18 December 2020

**RE: STOCKLAND SUBMISSION - CRAIGIEBURN WEST PRECINCT STRUCTURE PLAN (PSP)**

# Craigieburn West PSP Aitken Creek DSS Stockland Response

**Figure 1:** Proposed Place Based Plan demonstrating Conservation Reserve boundary amendment and subsequent co-location of the Active Open Space and Community Facilities.

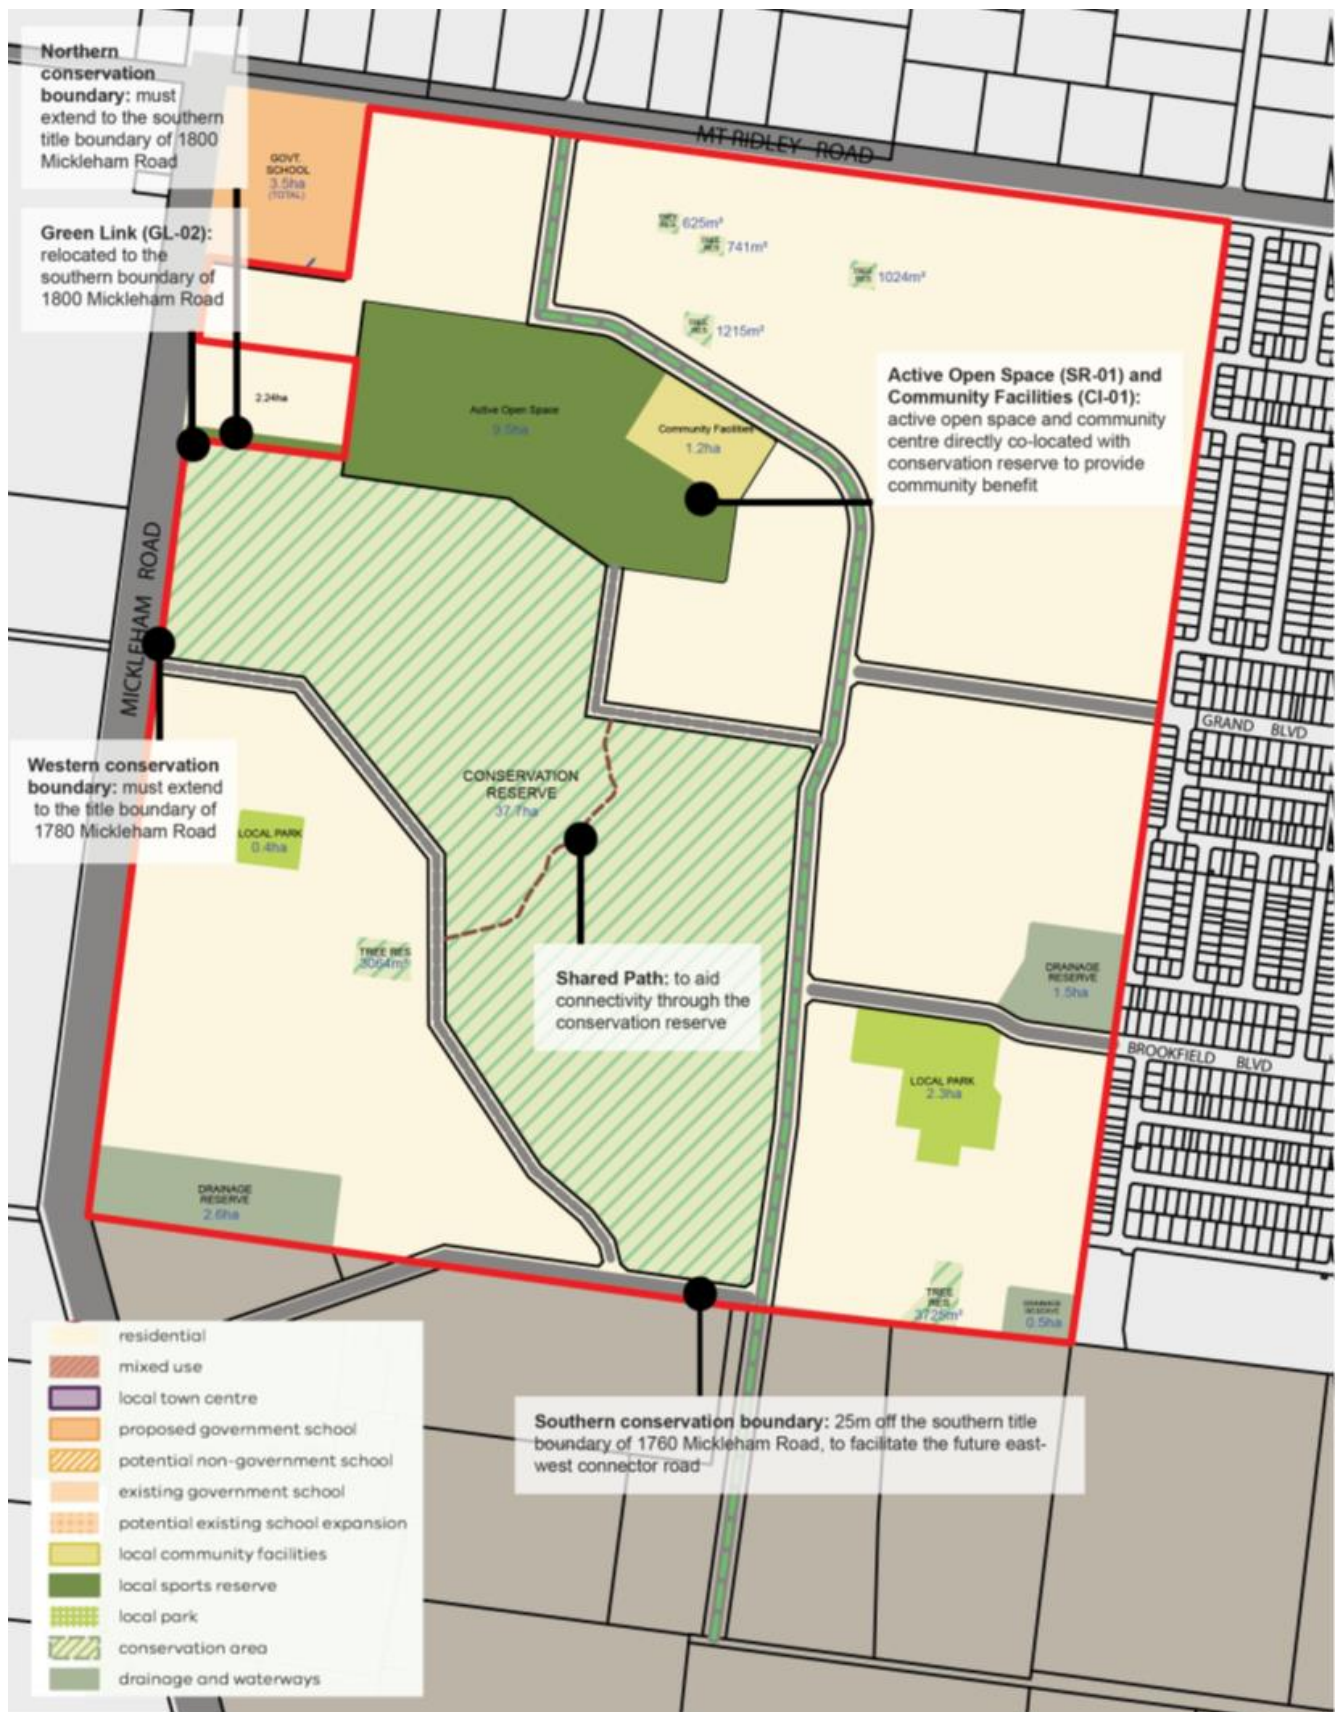
- That the amended Conservation Reserve boundary is generally in accordance with Stockland's Place Based Plan for 1760 & 1780 Mickleham Road (*Figure 1*).

- Southern conservation boundary – must be 25m off the southern title boundary of 1760 Mickleham Road, to facilitate the future east-west connector road.

- Western conservation boundary – must extend to the western title boundary of 1780 Mickleham Road.
- Northern conservation boundary - must extend to the southern title boundary of 1800 Mickleham Road, where the Conservation Reserve abuts 1800 Mickleham Road.

- That in order to aid connectivity there must be provision to construct at least one shared path connection through the Conservation Reserve (indicatively represented within *Figure 1*).

- The Active Open Space (SR-01) and the Community Centre (CI-01) must be directly co-located with the Conservation Reserve, as shown on Stockland's Place Based Plan for 1760 & 1780 Mickleham Road (*Figure 1*).

The relocation of the Conservation Reserve allows further consideration of the layout and integration of land uses within Stockland's landholdings. Having examined this (and conditional to our endorsement of the amended boundary of the Conservation Reserve) Stockland requests the subsequent relocation of the Active Open Space Reserve and Council's Community Facility. As detailed on the revised Place Based Plan (*Figure 1*), the relocation of these assets will allow a better and safer connection from the Active Open Space to the Primary School, as well as direct co-location of the future Council facilities with the Conservation Reserve. The capacity to locate the Community Facility directly with the Active Open Space Reserve that is then directly co-located with the Conservation Reserve will provide a superior place based outcome. This will create a unique community asset that provides a significant net community benefit than the separation of uses currently proposed by the PSP.

We consider that the changes as suggested above and outlined in Figure 1 are generally in accordance with the land use outcomes outlined in the draft PSP. We consider that given the improved environmental values assumed by the relocation of the Conservation Reserve and the subsequent co-location of the Active Open Space and Community Centre that the proposed outcomes are superior and provide a greater net community benefit. In addition, the changes as proposed ensure that all land uses are of the same extent and land area and only affect Stockland's landholdings and therefore do not have any negative consequences to other landholders.

In relation to the required land takes for these parks we suggest referring to our revised Place Based Plan (refer to *Figure 1*, above) which specifies the required land take to enable sufficient TPZs to be provided and will ensure the health of the trees in the urban environment. It also specifies the required land take for the trees to be retained in 1780 Mickleham Road parcel once the Active Open Space has been relocated, as detailed within section 1.2 of this submission.

**What is required:** Commitment and acknowledgement of the revised Conservation Reserve boundary and subsequent relocation of the Active Open Space and Community Facility to accommodate a net community benefit as demonstrated in the proposed Place Based Plan (Figure 1).

**What is required:** *Proper acknowledgement of the required land take and associated Open Space credit required to retain significant trees within open space network. Direct translation and credit of the required areas for parks associated with tree retention as based on Figure 1, above. Removal of Green Links GL-01 and GL-03.*

**Figure 2:** Realignment of the north-south connector road, to facilitate direct interface the Woodland Reserve, Craigieburn Road.

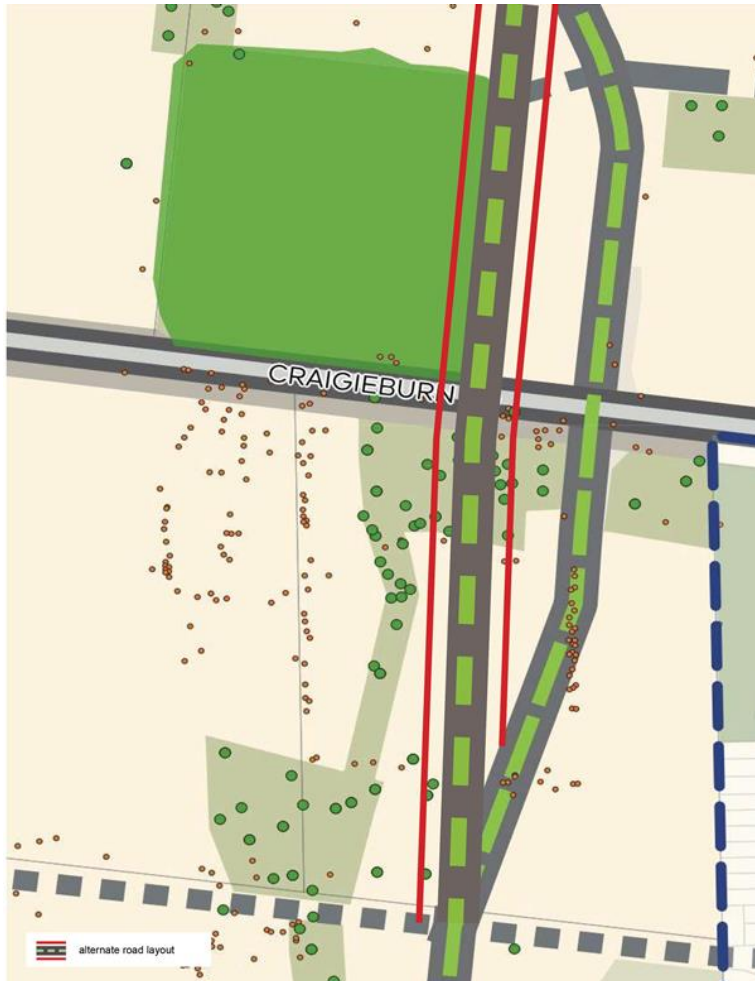
Table 4 of the PSP specifies that a 33 metre set back is required to the Woodland Reserve located at 680 Craigieburn Road. Currently the PSP demonstrates a local road interface to the Woodland Reserve that doesn't support the 33 metre separation to development. We submit that a preferred interface would instead be to realign the north-south connector road and have this road directly interface to the Woodland Reserve.

Figure 2 below demonstrates the preferred re-alignment of this road. We consider this will provide a better place making outcome that enables greater pedestrian and cycle mobility to the Woodland Reserve, will deliver a more cohesive, direct and logical street network, can be provided without the removal of additional trees and while not compromising the required traffic management outcomes and spacing for signals along Craigieburn Road.

**What is required:** *Realignment of the north-south connector road to align with the eastern boundary of the Woodland Reserve (LP-09).*

# Base Case: Melbourne Water's Draft DSS

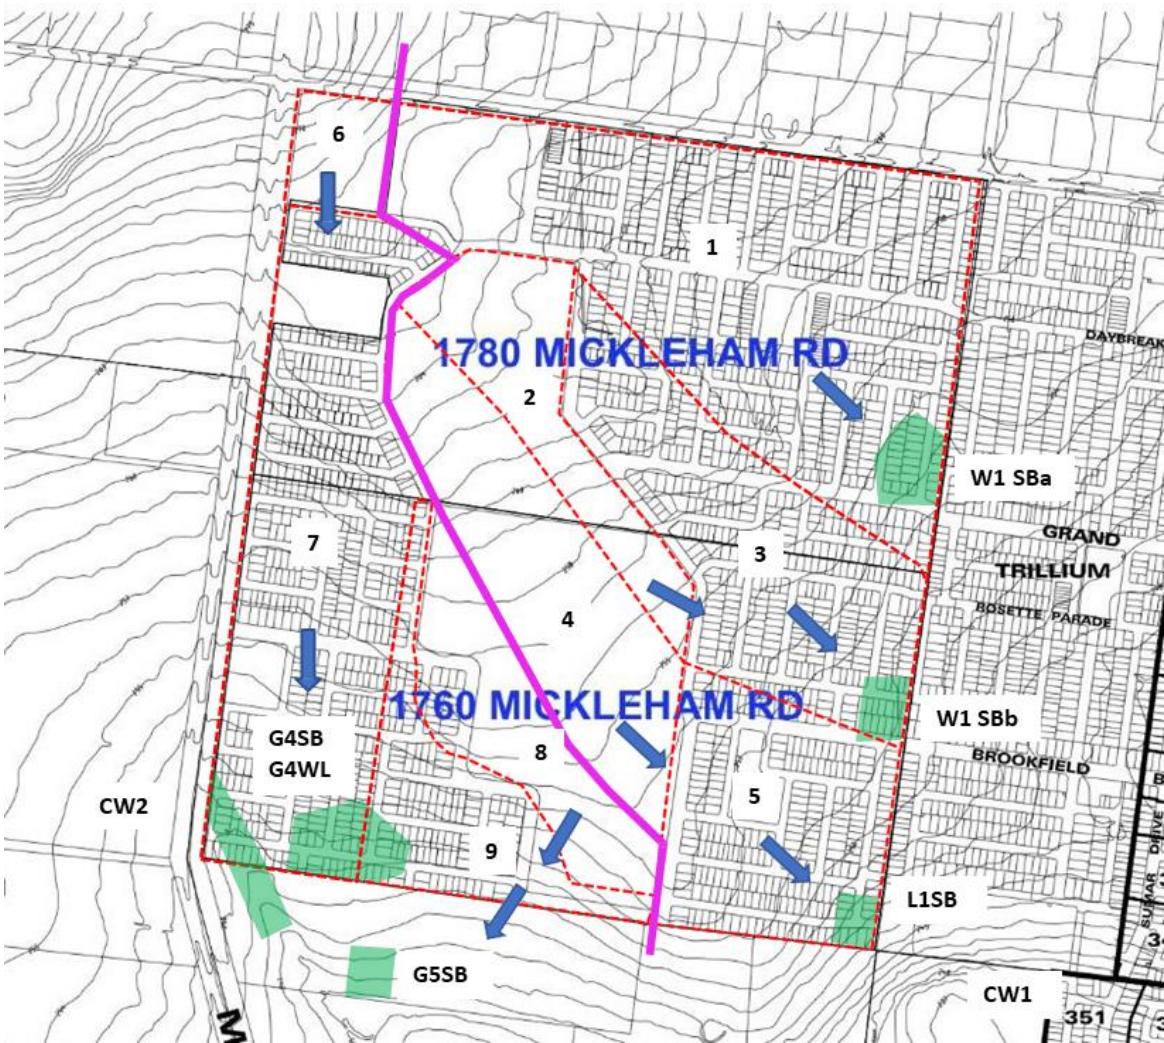
Asset	Contributing Subarea (ha)	Treatment area (ha)	Land Budget (ha)
East Catchment			
W1SBa	1 (41.60 ha)	0.6	0.89
W1SBb	2,3 (31.76 ha)	0.35	1.36
L1SB	4,5 (34.0 ha)	0.2	0.82
West Catchment			
G4SB/WL	6,7 (33.76 ha)	0.76	2.15
CW2	-	-	0.61
Total			5.83

Parameter	Annual Load (kg) generated from subareas 1,3,5,6,7,9	Pollutant Load (kg) removed by assets SB1a,SB1b,L1SB,G4SB/WL	Equivalent Pollutant load reduction
TSS	89300	66960	75%
TP	185	107.2	57.90%
TN	1287	479	37.20%

## DSS Recommendations

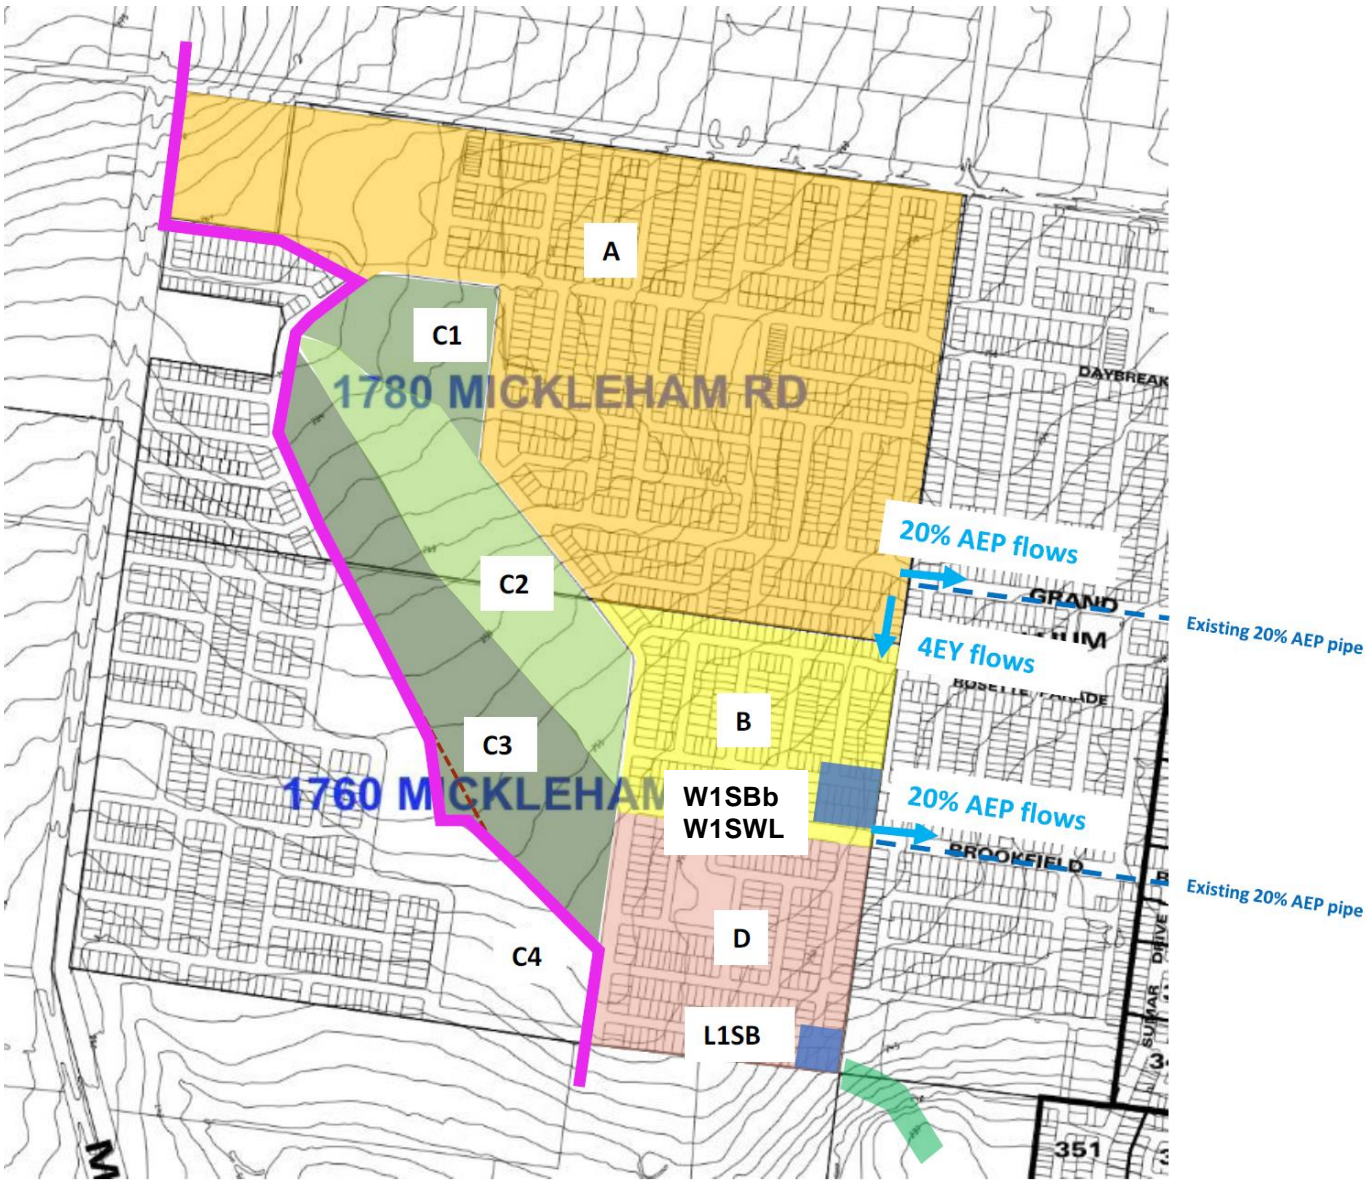
- 1) **Resize sediment basins** to meet best practice guidelines of targeting 95% removal of coarse sediments greater than 125 micron.
- 2) **Consolidate sediment basins** along the eastern boundary.
- 3) **Consolidate the constructed waterway and wetland** in the south west corner, given the existing waterway in the south west corner has no high intrinsic values and is located at the upstream end of the catchment.
- 4) Opportunity to **drain subareas 8 and 9** into the **G4WL wetland**.

# Recommendation: DSS Arrangement Plans

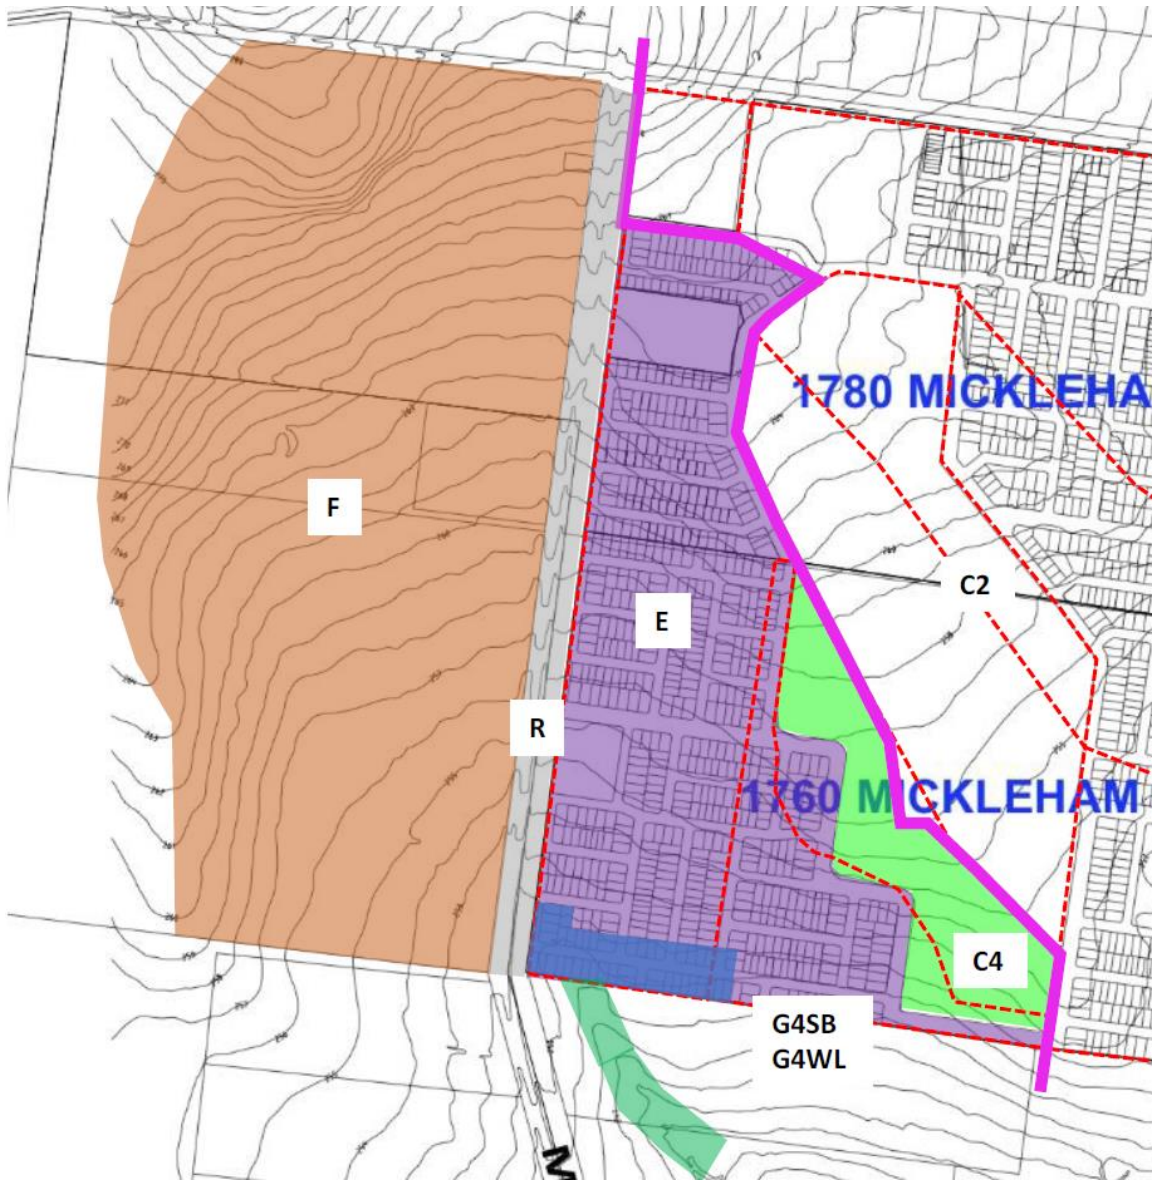
1. Consolidation of assets along the eastern boundary, resulting in the removal of sediment basin ACSB 01 and consolidating these drainage requirements into sediment basin ACSB 02; and
2. Consolidation of the northern reach of the constructed waterway, CW2 (within 1760 Mickleham Road) with wetland ACWL01 into a single asset.<sup>1</sup>

# Recommendation: DSS Treatment Performance & Land Take

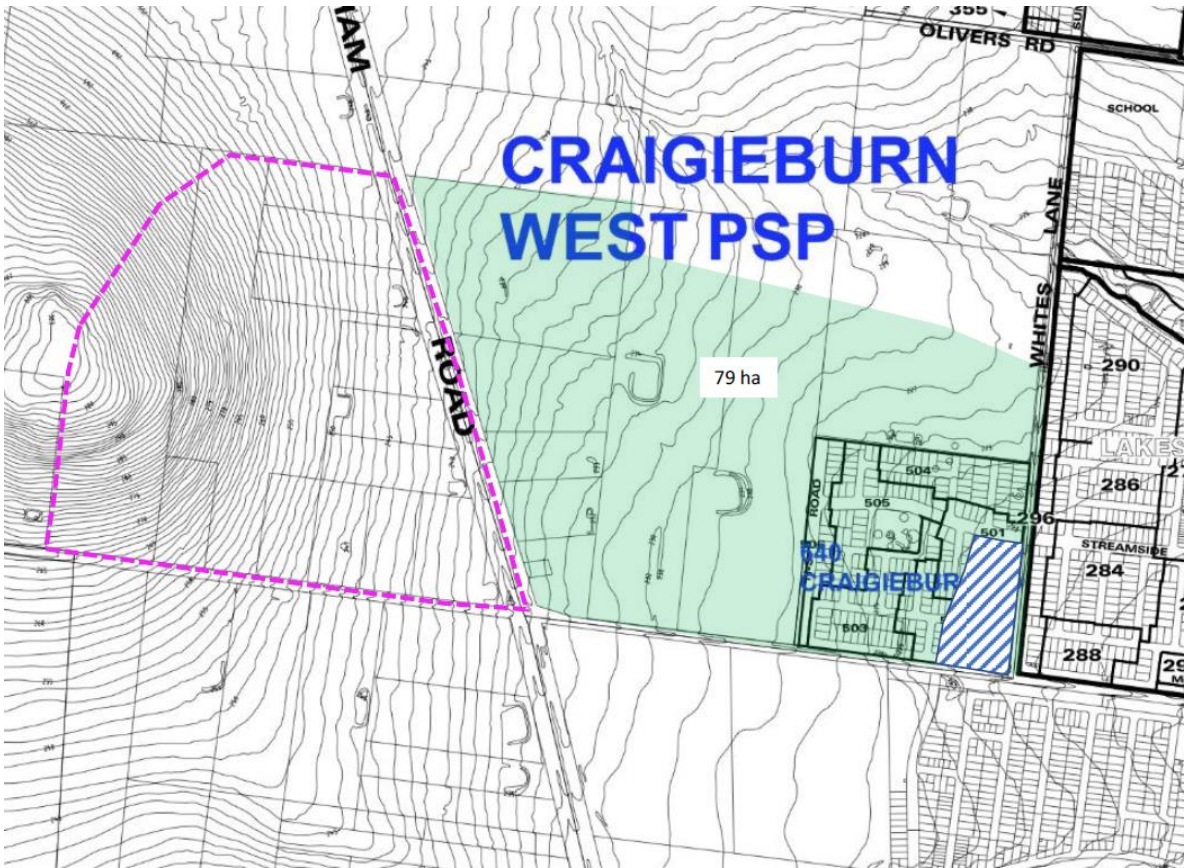
Parameter	Annual Load (kg) Generated (subareas A,B,D,E)	Pollutant Load (kg) Removed (MW Base Case)	Pollutant Load (kg) Removed (Recommendation)	Pollutant Load Reduction (MW Base Case)	Pollutant Load Reduction (Recommendation)
TSS	89300	66960	66300	75%	74%
TP	185	107.2	113	57.9%	61.1%
TN	1287	479	473	37.2%	36.8%

Asset	Contributing Subarea's	Recommendation Treatment Area (ha)	MW Base Case Land Budget (ha)	Recommendation Land Budget (ha)
EAST CATCHMENT				
W1SBa	NA	NA	0.89	NA
W1SBb	A, B, C1, C2	0.16	1.36	1.5
W1SWL	(84.4ha)	0.42		
L1SB	C3, D	0.05	0.82	0.5
	(28.1ha)			
WEST CATCHMENT				
G4SB	C4, E, F, R	0.08		
	(148.5HA)			
G4WL	A, B, C1, C2	1.00	2.15	2.6
	(84.4ha)			
CW2	NA	NA	0.61	0
Total			5.83	4.6

- 1) Sediment basins sized in accordance with design guidelines
- 2) Optimised land take
- 3) Equivalent load reduction compared to the Melbourne Water base case
